AXC F 2152 – CHANGE NOTES

Change notes for the AXC F 2152 controller

Application note
108427_en_08

Left-alignable INTERBUS master

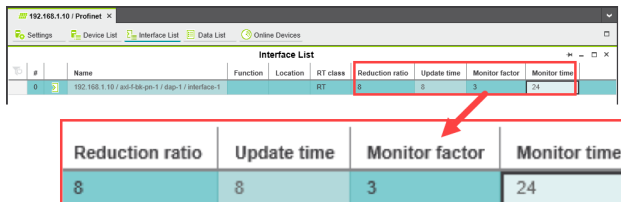
The controller now supports left-alignment of the INTERBUS AXC F XT IB master (Order No. 2403018).

Figure 2 Select Trigger task

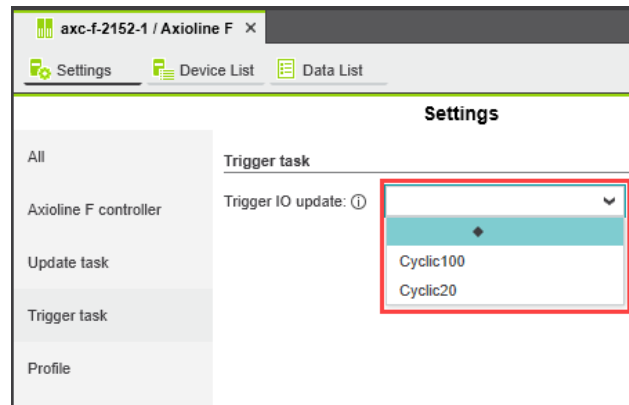
You can now specify the refresh interval for Axioline F I/O data. This is done by selecting which task triggers the Axioline F I/O data update in the PLCnext Engineer project.

- Select the “Trigger task” view in the “Settings” editor.
- In the drop-down list, select the task that is to trigger the Axioline F I/O data update.

If you do not select a task, the update will occur by default every 50 ms.
